DATE: February 23, 1972

SUBJECT: Fuel Tank Vent Line Inspection and Modification

SERIALS AFFECTED: AA5-0002 through AA5-0045

FIGURE 1A

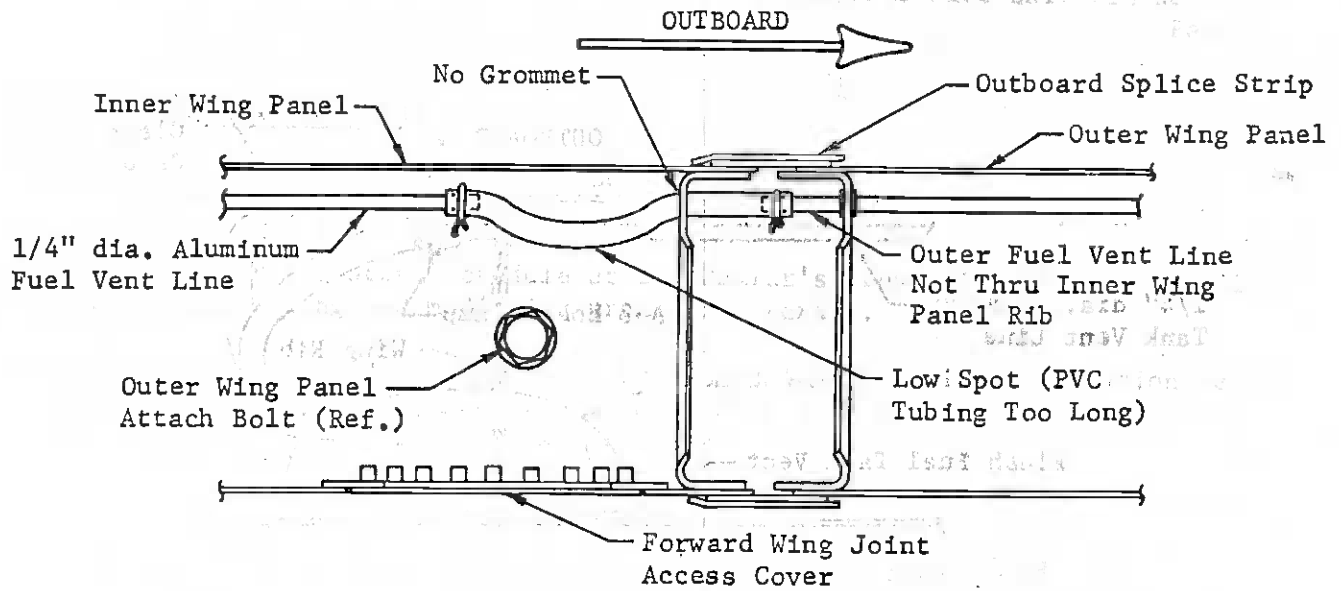
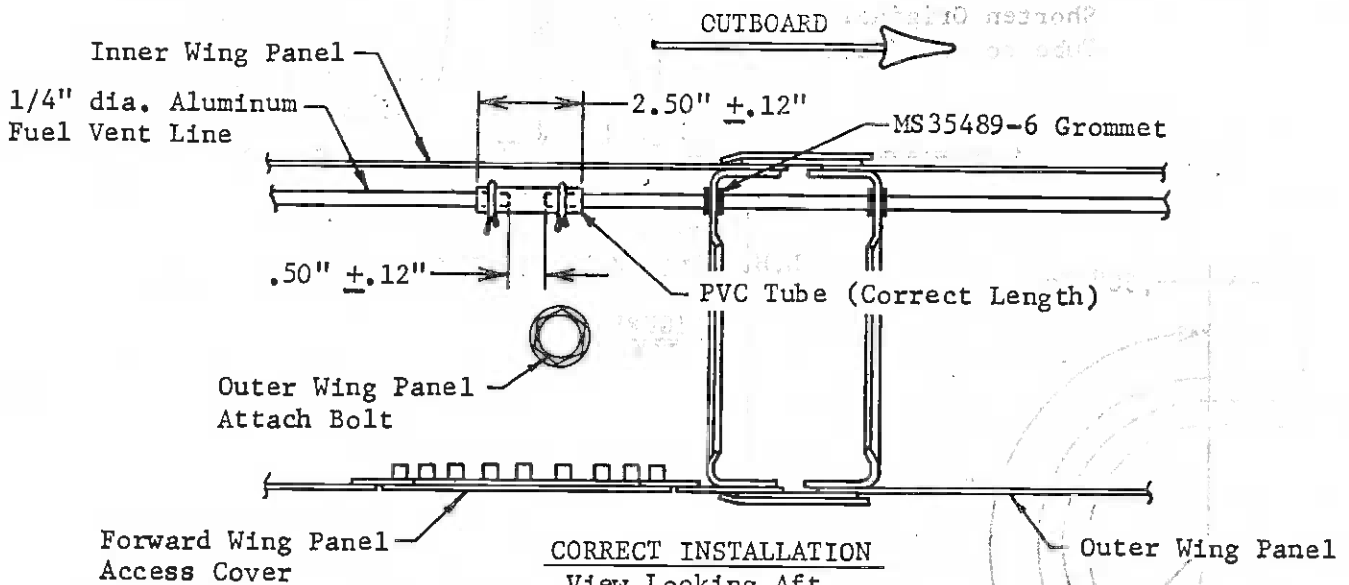
Aircraft that have the vent line splice joint configuration as shown in Fig. 1A must be modified to the joint shown in Fig. 1B. Any change in this joint requires

1. Remove existing long length of PVC tubing (Fig. 1A).
2. Install a rubber grommet part no. MS35489-6 in the wing rib hole that the PVC tubing passed through originally.
3. Slide a 2 1/2" long length of PVC tubing 1" onto the inboard vent line and clamp in place. (use a section of the original tubing removed in step 1)
4. Slide the hose clamp over the outboard tube and insert the aluminum tube into the PVC connection approximately 1" until a 1/2" gap exists between the ends of the aluminum tubes.
5. Install the clamp on the PVC tube completing the connection and replace the inspection cover.

FIGURE 2A

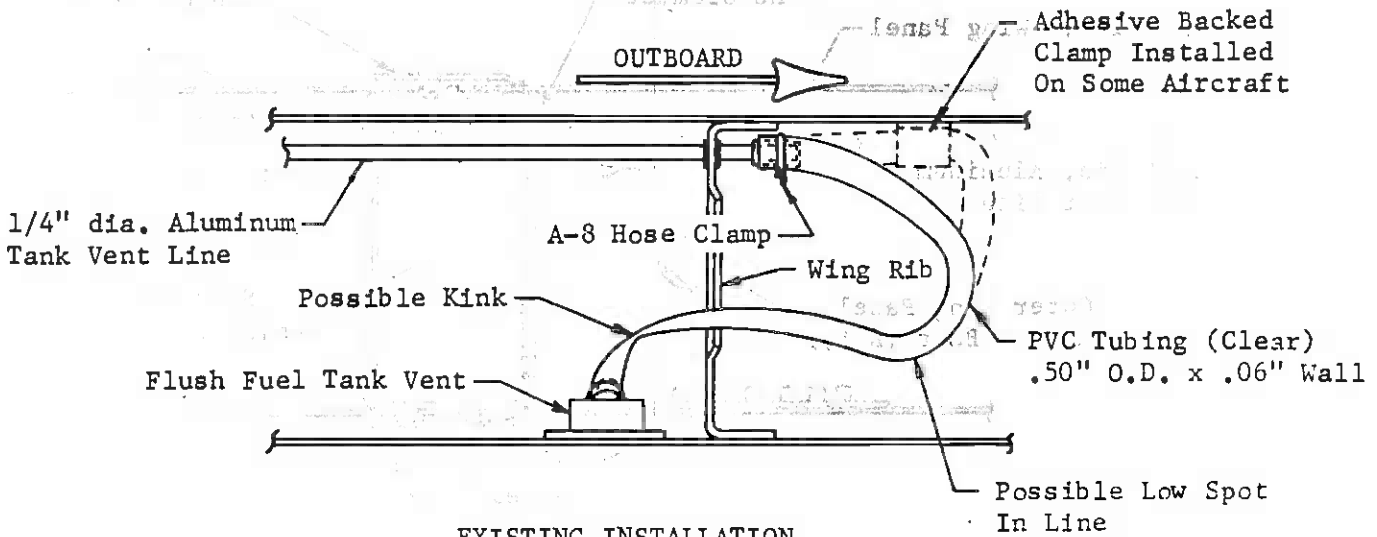
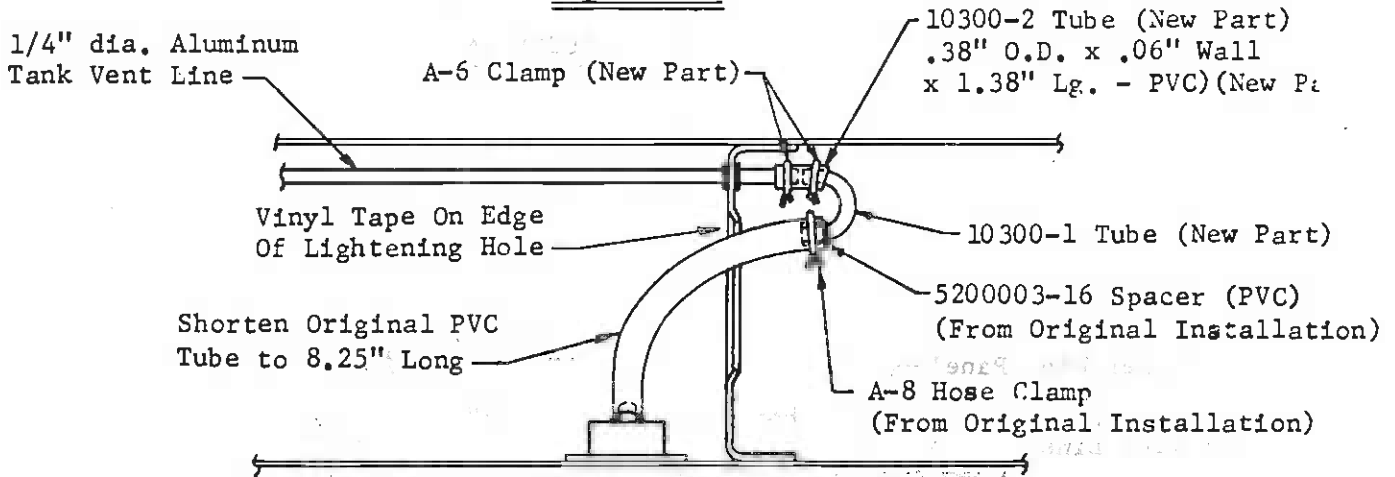
The outboard vent line to vent housing PVC tubing connections must be modified per Fig. 2B as follows:

1. Verify that aircraft complies with modification No. 1 before starting this modification.
2. Remove both wing tips.
3. Disconnect the 1/2" dia. PVC tube and remove PVC spacer from 1/4" dia. aluminum tank vent line (upper connection). Some aircraft have an adhesive backed plastic clamp mounted to the upper wing skin supporting the existing loop in the PVC tube. This clamp should be removed from the aircraft.

4. Install the 1 3/8" long x 3/8" O.D. PVC tube (part no. 10300-2) and the 1/4" dia. aluminum tube 170° bend (part no. 10300-1) on the outboard end of the existing vent line per Fig 2B, using (2) #A-6 hose clamps (Corbin).

5. Shorten existing 1/2" O.D. PVC tube to approximately 8 1/4" long, insert #5200003-16 spacer (PVC) removed in step 3 and clamp to the 170° bend tube with #A-8 original hose clamp, being sure tube is properly positioned and is free of kinks.

6. Remove fuel tank filler cap. Then to verify that the vent line is open and properly connected, carefully blow air (10 p.s.i. max.) into the vent line opening located on the bottom outboard wing surface. CAUTION - BE SURE FILLER CAP IS OFF BEFORE APPLYING AIR, TO AVOID PRESSURIZING THE FUEL TANK.
